## Proposal for editorial correction to ECE/TRANS/WP.29/GRE/42

(Collective amendments to Regulations Nos. 3, 6, 7, 48, 77 and 91)

GRE-68-02 Corr.1 (This document) contains editorial corrections following a review with the GRE secretariat to ensure that the proposal is in line with the latest state of the regulations including amendments submitted for WP29-158. These are also identified in the comments added to the right-hand column.

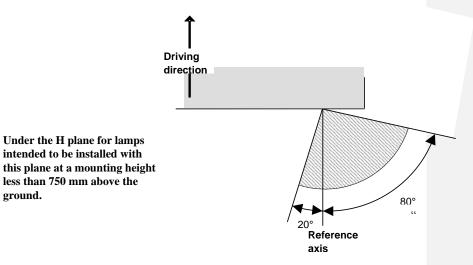
This is the correction of the text shown in GRE/2012/42

During the preparation of this proposed collective amendment the replacement of the wording "reference axis" by "H-Plane" was erroneously omitted in the proposal C. Add a new diagram and associated text, to read:

Rear position lamps,

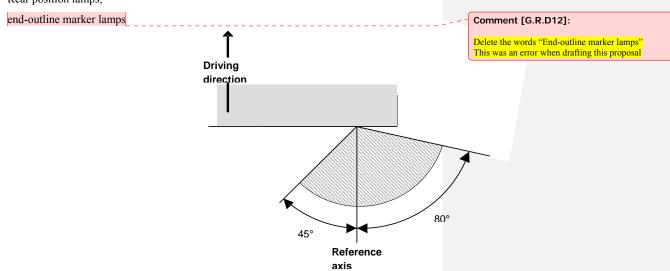
Front position lamps, Under the H plane for M1 or N1 category vehicles. Add a new diagram and associated text, to read:

Under the H plane for front position lamps intended to be installed with this plane at a mounting height less than 750mm above ground.

"Stop-lamps (S1 and S2)

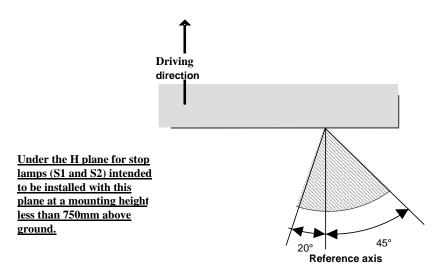
Add a new diagram and associated text, to read:
